# City of Alexandria, Virginia

## MEMORANDUM

**SUBJECT:** UPDATE ON PERMIT TO DEMOLISH, ADDITION AND ALTERATIONS  
AT 207 PRINCE STREET, BAR CASE #2013-0066 & 0067

## Physical Investigation and Documentation of the Fairfax–Moore–Montague House Kitchen

Figure 7: Existing first floor

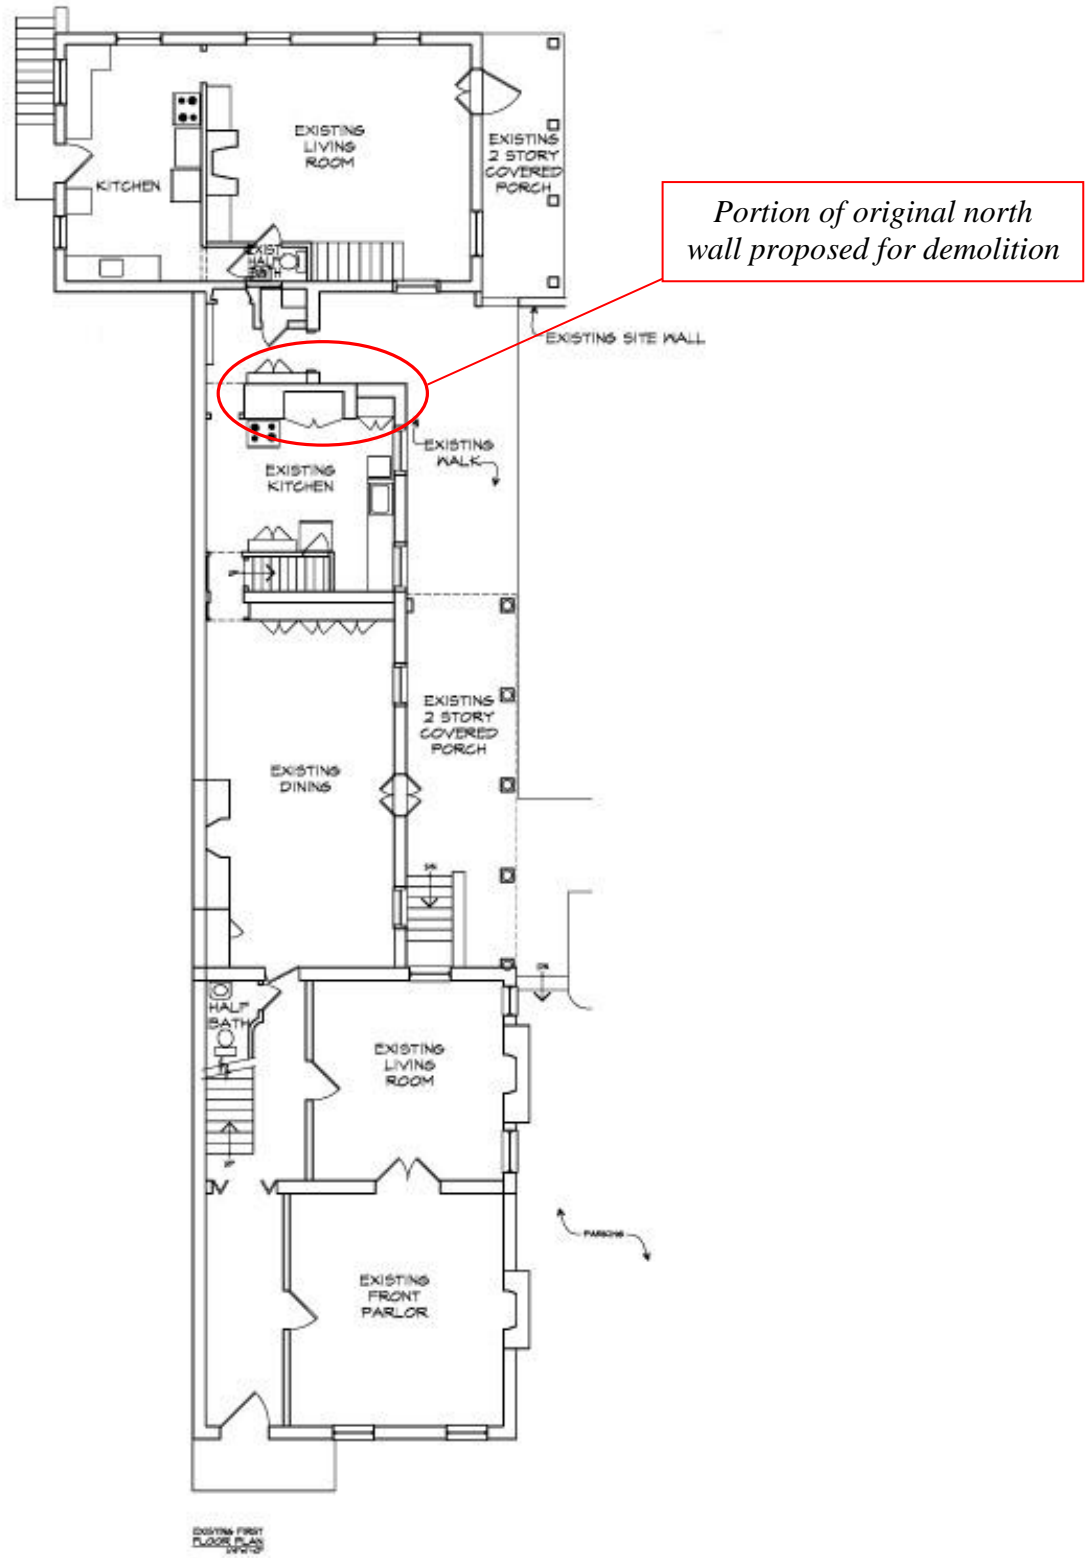
**Figure 5:** Portion of the east elevation at the first floor that is proposed for demolition and capsulation for the kitchen addition

**Figure 6:** Existing east elevation, as presented by applicant

**Figure 9:** Initial proposal showing first floor plan, as submitted by applicant. Both the north and east masonry walls of the existing kitchen are removed entirely at the first floor.

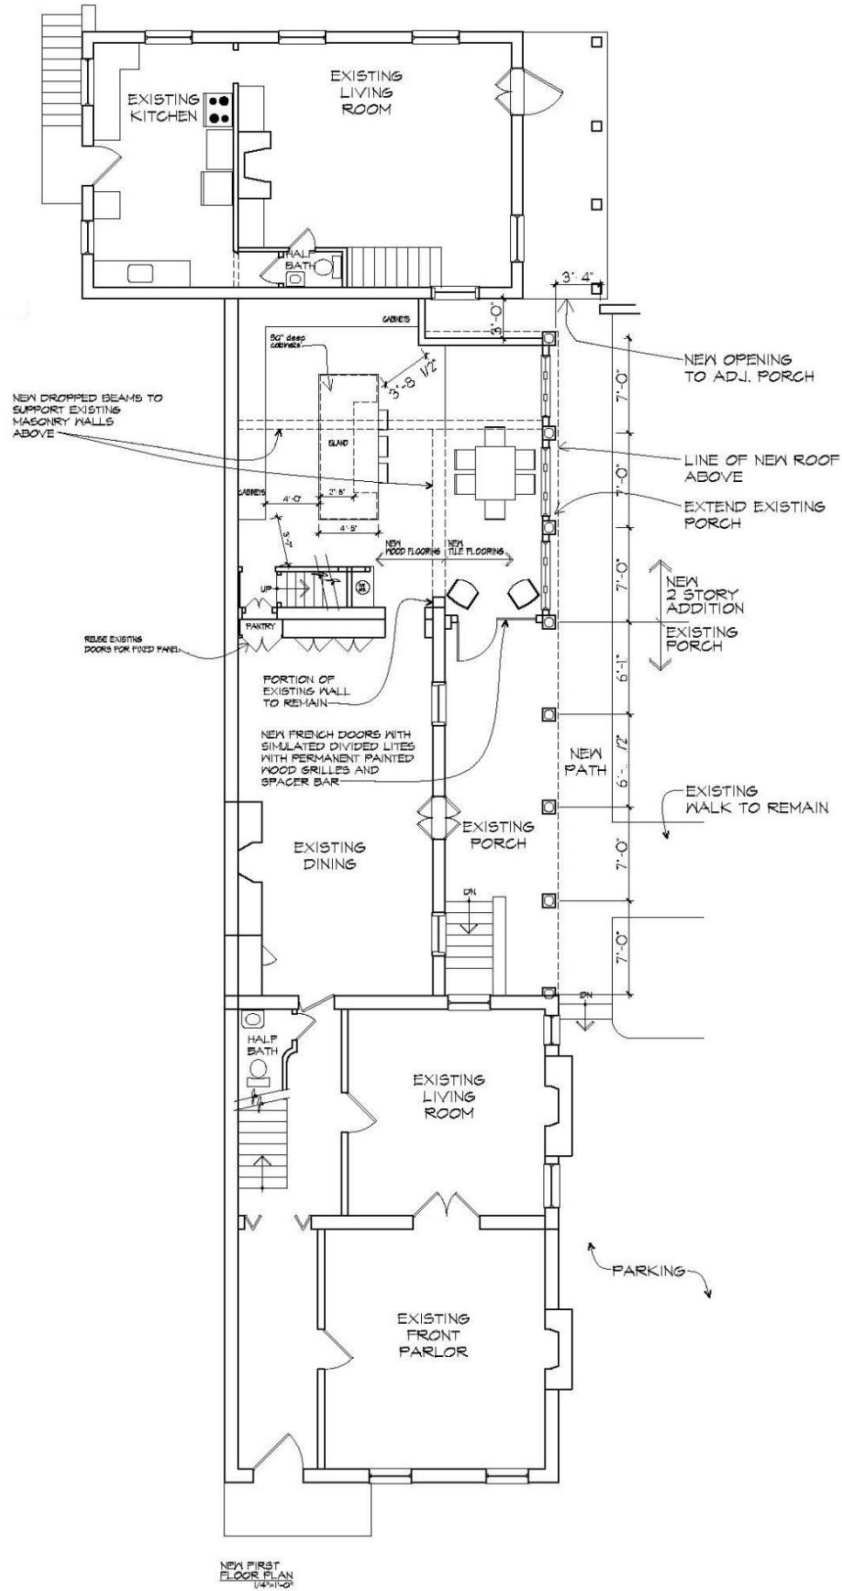
**Figure 8:** Initial proposal for east elevation, as submitted by applicant in March 2013. Note that the proposed replication and northern extension of the mid-20<sup>th</sup> century, two story open porch obscures the original kitchen ell of the house. In this scheme, the modern porch becomes the dominant design feature. The north end of the porch also ends awkwardly in the middle of the hyphen windows.

Staff expressed concern with the initial design, as the proposed addition significantly diminished legibility of the northern portion of the ell, where the existing kitchen is located, as a discreet building feature. The proposed second-story porch matched exactly the existing porch, now historic in its own right, and then obscured the building masses that comprise the historic ell. This made it difficult to understand the growth and development of the original dwelling and is contrary to the Secretary of the Interior's Standards for Rehabilitation, particularly #9 and #10 which state that:

Figure 11: First floor alternate design presented by BAR Staff that preserves the historic masonry walls in what is, perhaps, the oldest part of the house

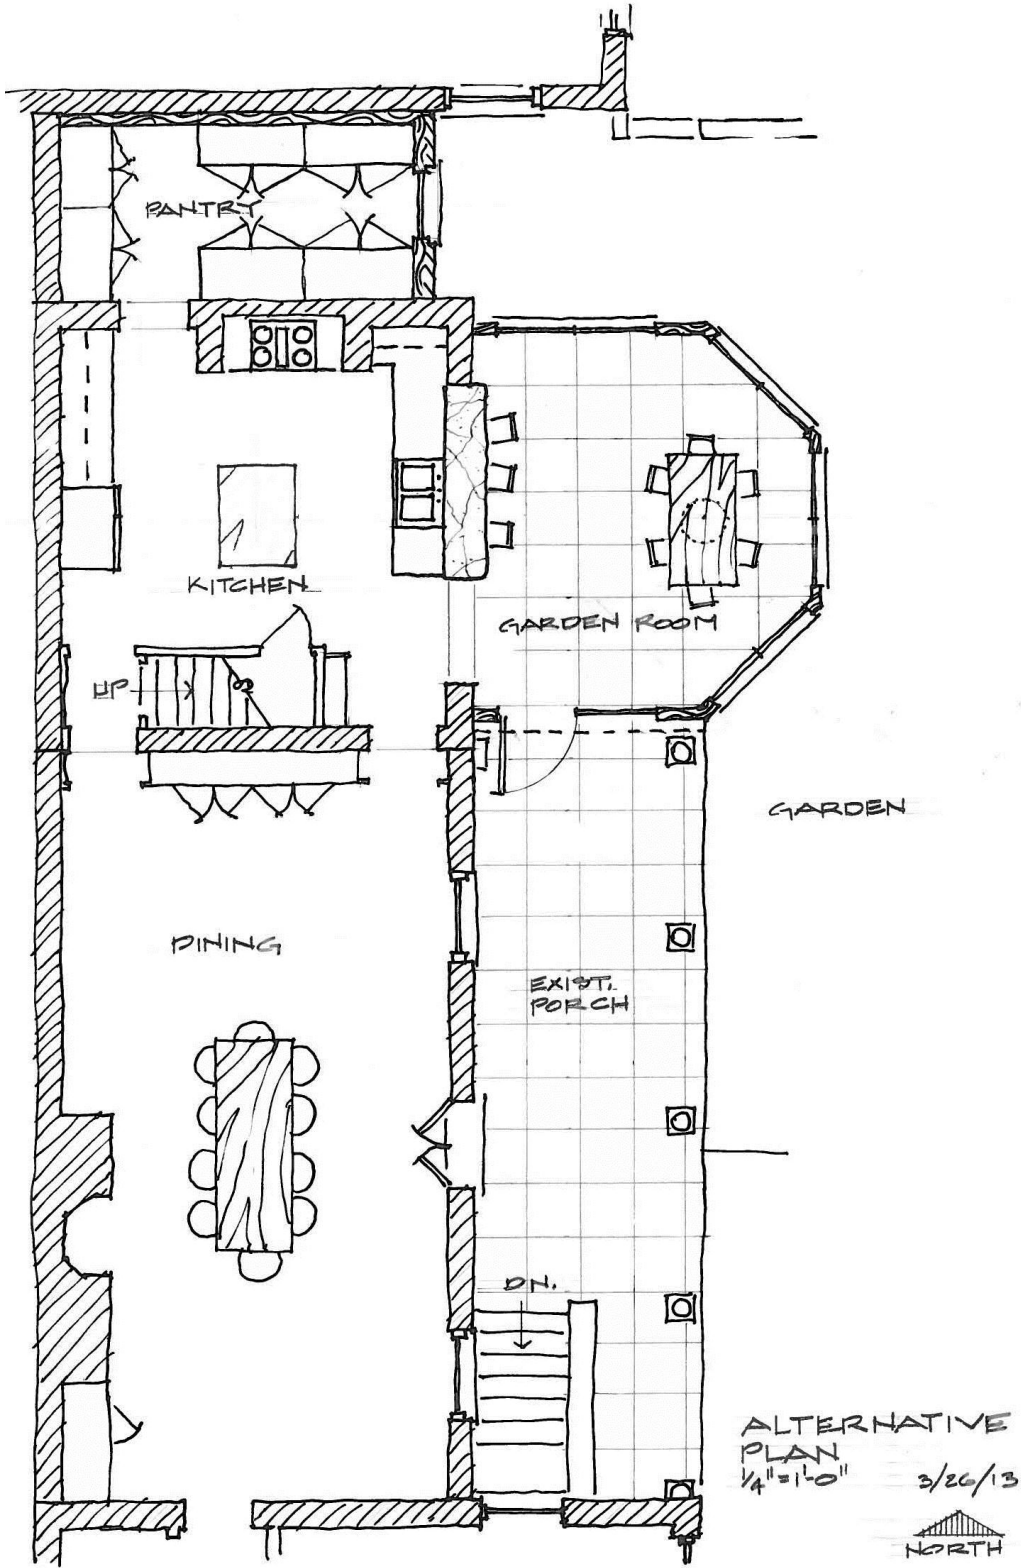
Therefore, Staff recommended to the applicant an addition much smaller in height and floor area that does not try to match the original building or the 1930's Colonial Revival alterations, but stands on its own. A delicate single story kitchen projecting slightly beyond the existing porch, much like a Colonial Revival conservatory, would read as a garden feature rather than part of the house and take up very little useable open space in the garden. Like the plan submitted by the applicant, a one-story addition would still provide generous kitchen work space, substantial pantry storage and circulation for entertaining and daily use by the family. The masonry opening to the garden room could be a large segmental masonry arch with a wood vaulted ceiling in the garden room/breakfast area to allow light back into the kitchen. A similar design was recently approved by the BAR at 504 Prince Street. The alternative designs suggested by Staff are illustrated in *figure 10* and *figure 11*.

Figure 10: Alternate design suggested by BAR Staff

Figure 13: Revised proposal by applicant and current application submission

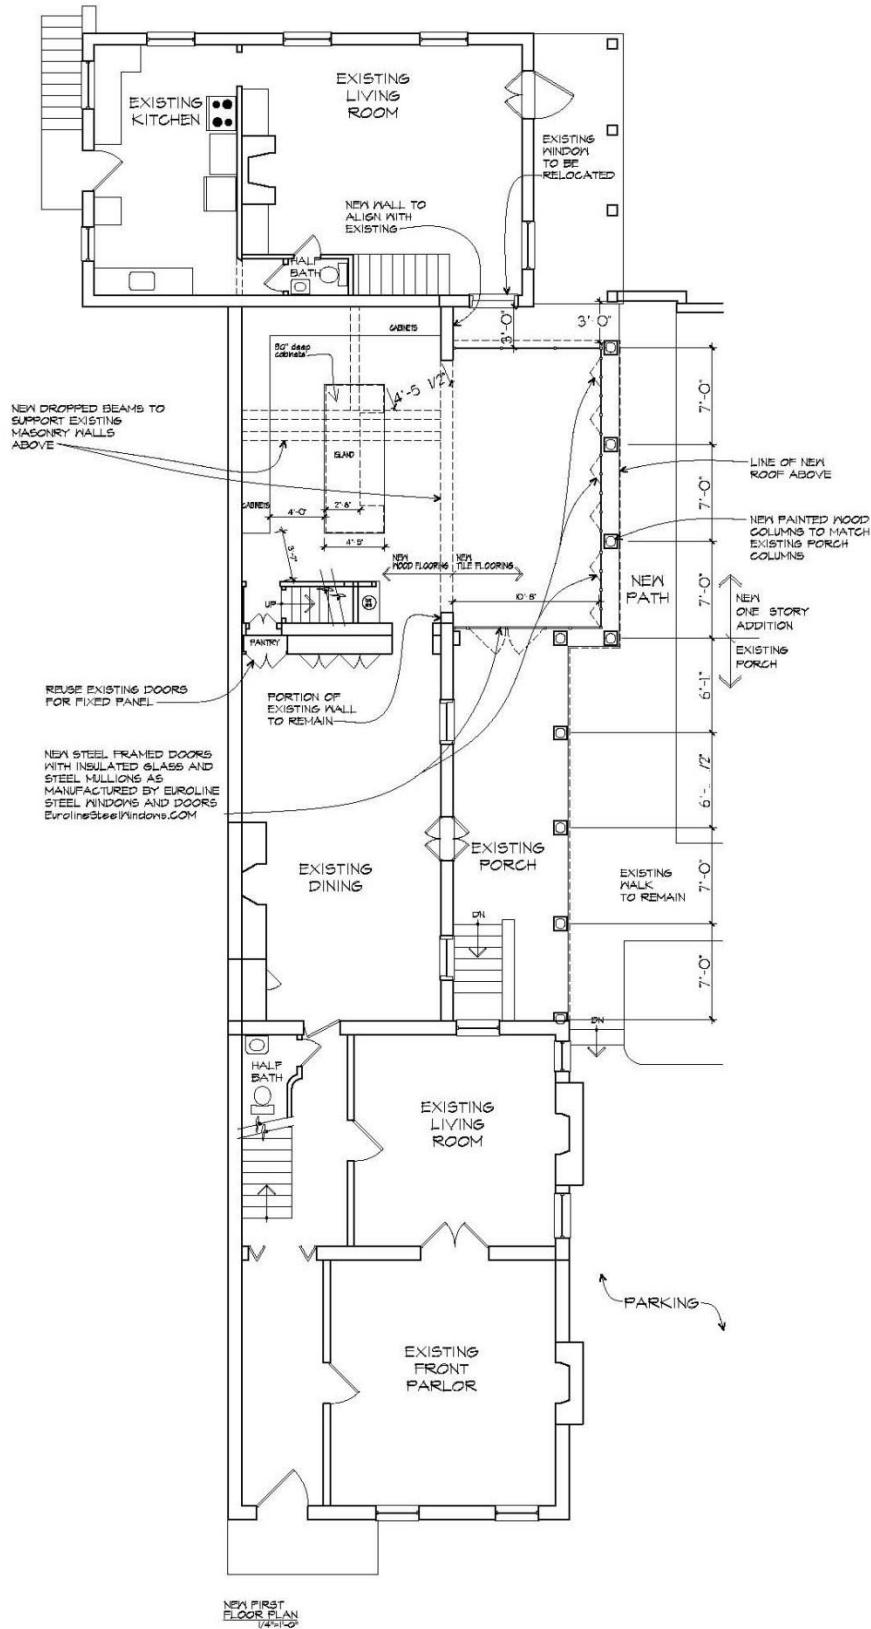
Figure 12: Revised proposal by applicant and current application submission

Although Staff would prefer that a greater portion of the north and east masonry walls at the first floor be preserved and incorporated into the new plan, Staff acknowledges that these masonry walls have been altered many times in the past and has no objection to the exterior design of the proposed kitchen addition. As historic maps and photographs show, there have been several alterations to the east elevation over the years. The visual mass of the proposed addition has been significantly scaled back since the initial application and its impact on the existing east elevation minimized by the elimination of the second story covered porch.

The proposed enclosed porch design parti is often used on historic buildings to avoid competing with the primary building mass. The size and spacing of the new columns recall the existing porch without replicating the segmental arch detail of that Colonial Revival era design. The modern steel and glass doors on the proposed addition float behind the columns and clearly distinguish this infill as a modern addition. The applicant has alluded to floor material changes and ceiling design that will visually interpret the location of the original masonry walls and it is Staff's recommendation that this be made a condition of the Certificate of Appropriateness. Furthermore, Staff recommends that an approval for a Permit to Demolish include the condition that the historic floor joists of the first and second story remain in place. These alterations, if approved, will preserve the historic integrity and understanding of the evolution of this important house while allowing its inhabitants a contemporary kitchen and living space.
